CITY OF CAPE TOWN	
C.E.'s Dept.	B.S. Branch
Survey Fee R. 0.00	Balance R.
Minimum Fee R. 0.00	Receipt No.
Date 11/11/11	Date
Site Inspected 0.5	Ward No.
Building Inspector	Storm Water Connection R.

NEW OUTSIDE TOILET TO EXISTING RESIDENCE FOR
MR. W.J. RAGGETT
ERF 265 2 OCEAN VIEW DRIVE
GREEN POINT
CAPE TOWN
JULY 1984

SITE PLAN scale 1-100

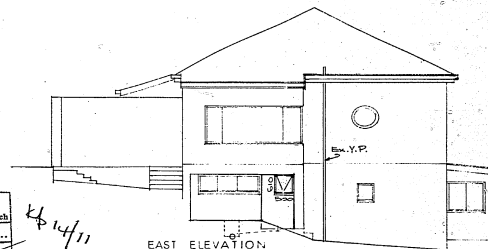
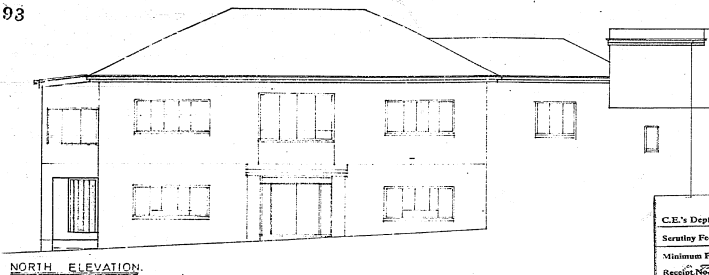
EVERY PORTION OF EVERY MASONRY WALL WHICH IS VISIBLE FROM ANY STREET OR OTHER PUBLIC PLACE OR FROM ANY OTHER PROPERTY IS TO COMPLY WITH THE REQUIREMENTS OF REGULATION 117.

- (1) Where cover less than 500 mm pipes to be encased in concrete.
- (2) Plastic curtains to showers.
- (3) Air bricks to WCs and bathrooms.

WATERWORKS BRANCH
PRIVATE PIPES TO BE ALTERED SO THAT THEY ARE CLEAR OF NEW FOUNDATIONS.

WATER ENGINEER'S REQUIREMENT
The existing water supply connection may be used. In the event of a direct off main building or hot water cylinder system it will refer back to Water Works Branch for resolution.

Waiver of Reg 55(5)
has been granted by the City Engineer Building Surveyor in terms of Delegated Powers to plan to a 1.9 high sewer
will to be

BOUNDARY INSPECTION CHAMBER COVER LEVEL MUST BE AT ADJACENT ULTIMATE STREET LEVEL AT BOUNDARY OR HIGHER. ALL OTHER INSPECTION CHAMBER COVER LEVELS AND GULLY RISES TO BE AT LEAST 75mm ABOVE THE BOUNDARY INSPECTION CHAMBER COVER LEVEL.
FLOOR LEVELS OF ROOMS CONTAINING APPLIANCES LINKED TO THE SEWERAGE SYSTEM ARE TO BE A MIN. OF 125mm ABOVE THE LEVEL OF THE BOUNDARY CHAMBER COVER.
COUNCIL WILL NOT BE LIABLE FOR ANY FLOODING, DAMAGE OR ADDITIONAL COSTS IF THESE CONDITIONS ARE NOT COMPLIED WITH.
